### Correspondence with California Department of Transportation (Caltrans)

RE: San Diego International Airport Land Use Compatibility Plan Update

# *Appendix E*

## Airport Facilities and Operations

Exhibit E-1    Airport Layout Plan..... E-3

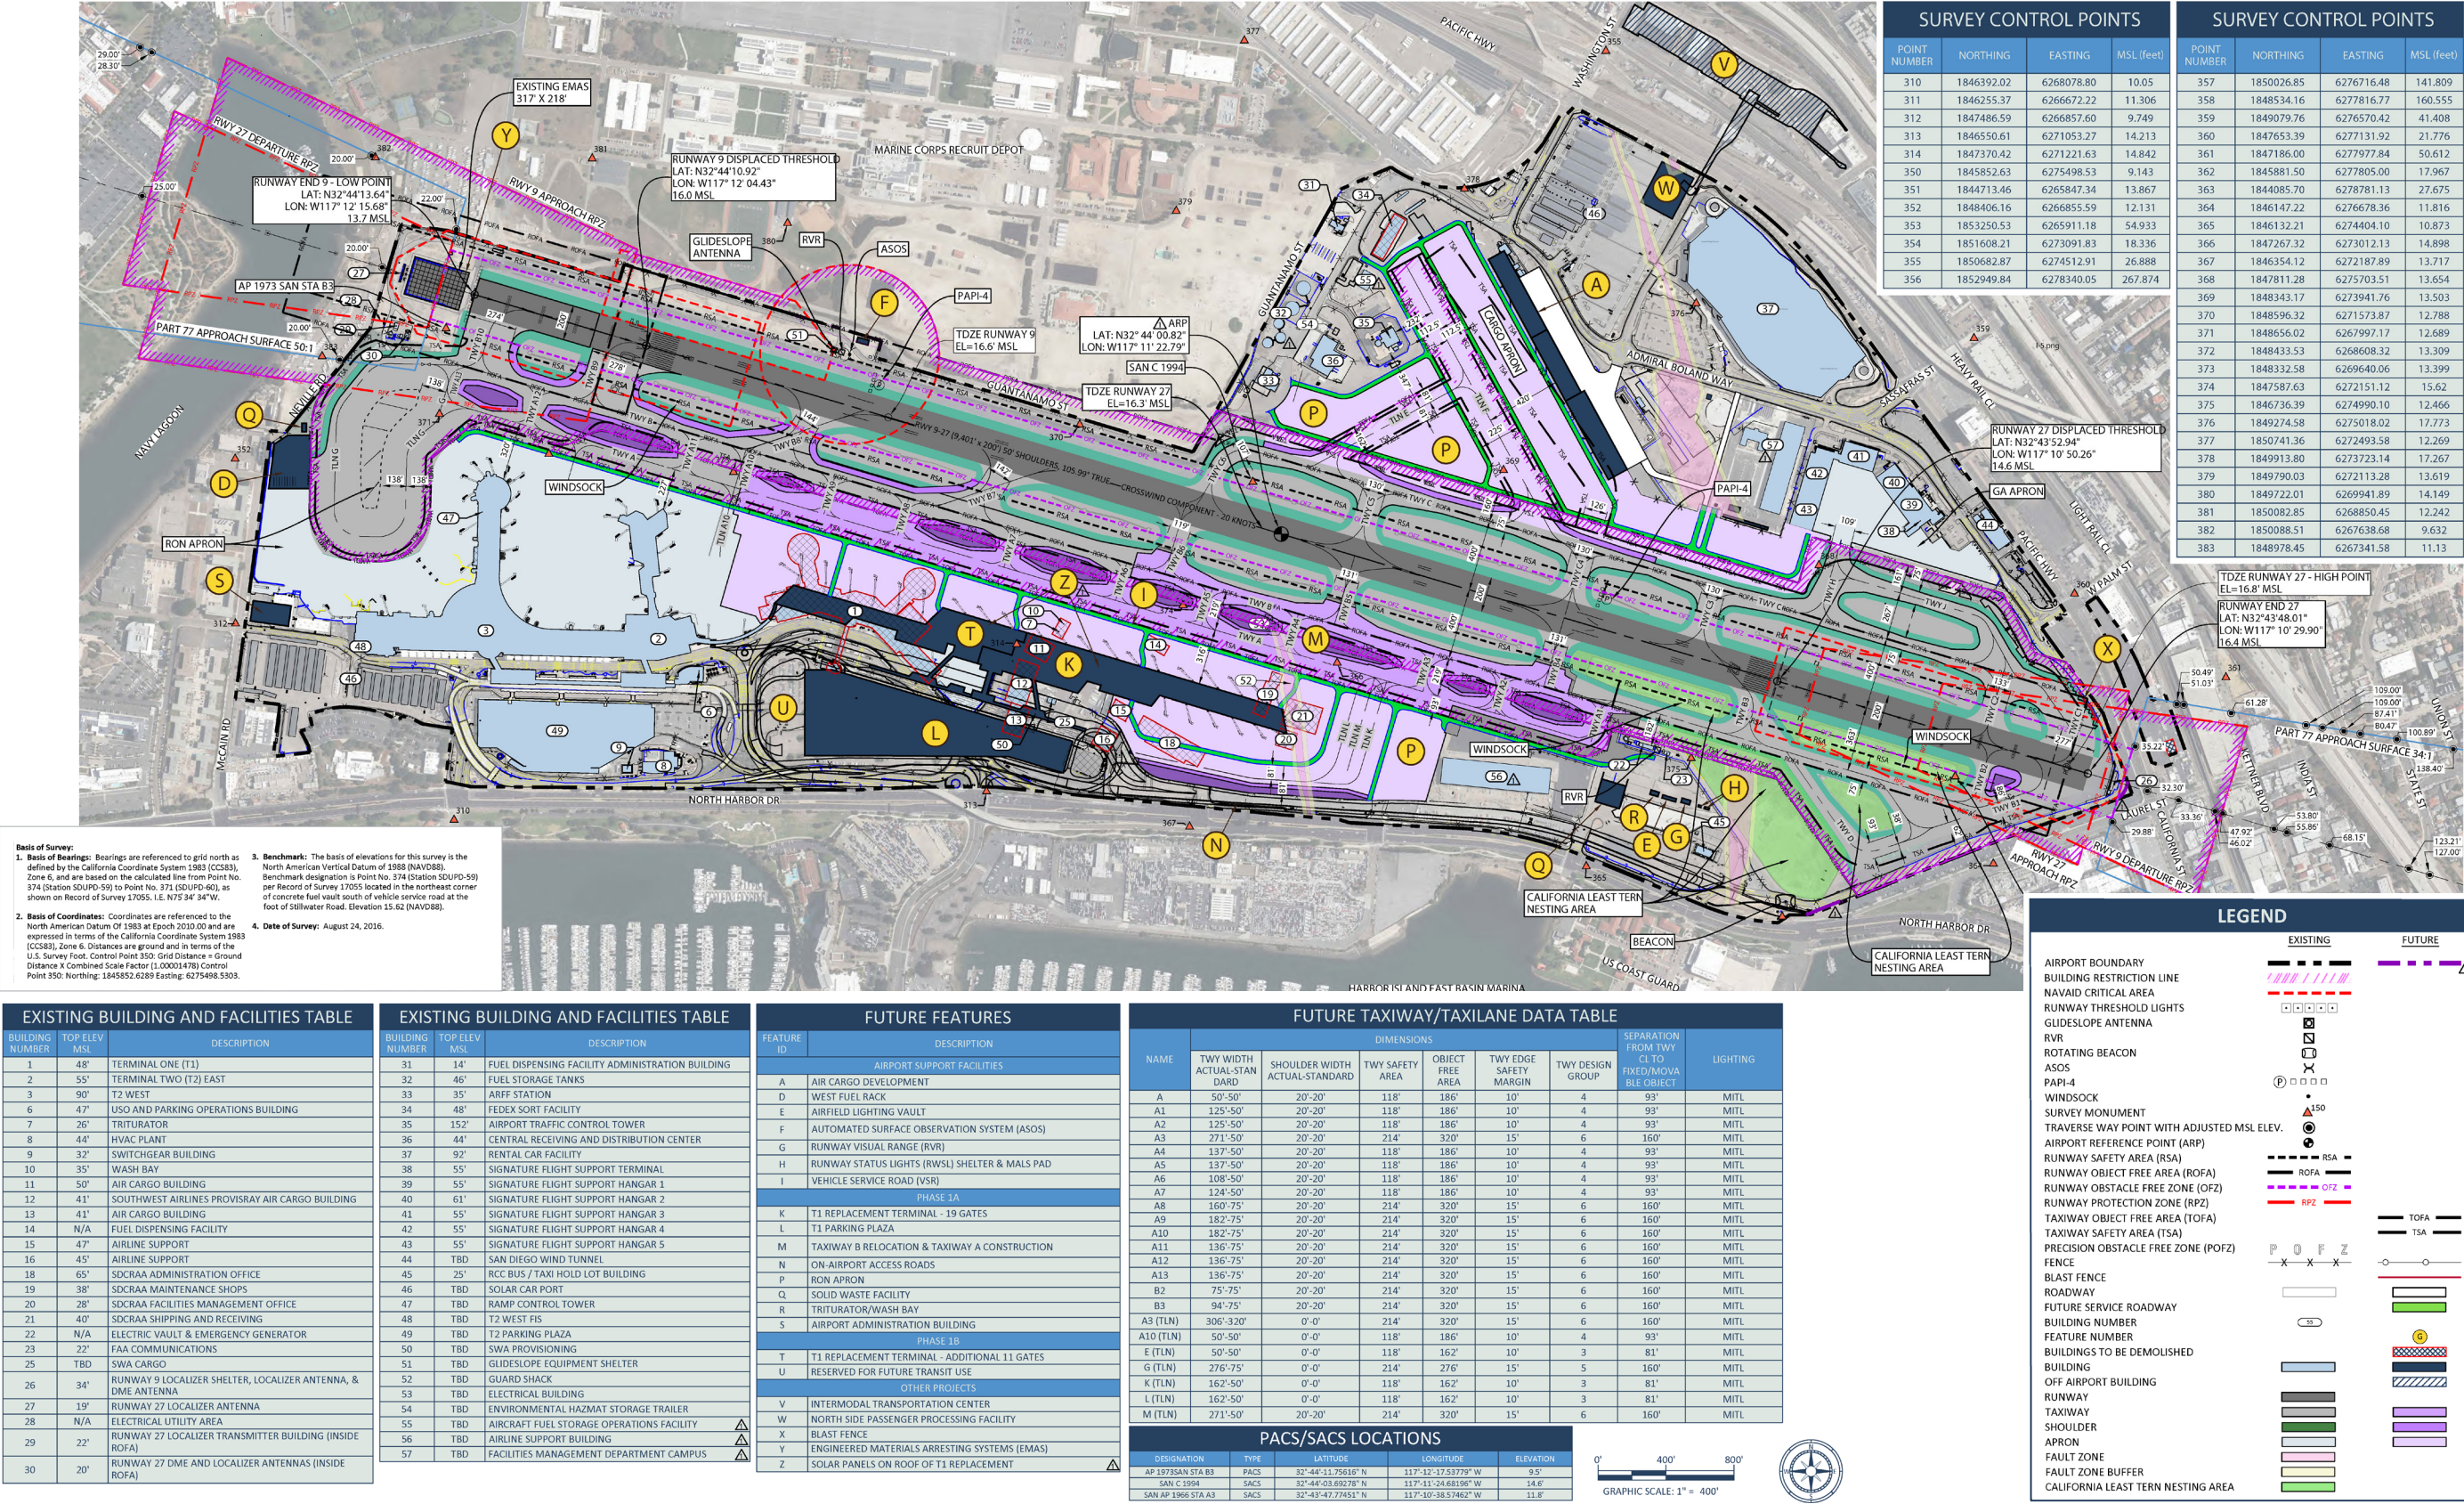
Per your findings, the updated ALP has no effect on the draft ALUCP, as it proposes no changes to the runway, runway thresholds, or runway protection zones. The approved ALP and draft ALUCP document must be consistent with one another.

This letter serves as the Aeronautics Program review and acceptance of the submitted SDIA ALP, for the inclusion into the draft ALUCP. Please note that any proposed changes must be reviewed and approved by the Aeronautics Program to ensure the State's participation.

Our office has reviewed the SAN ALP and Forecast and have no comments.
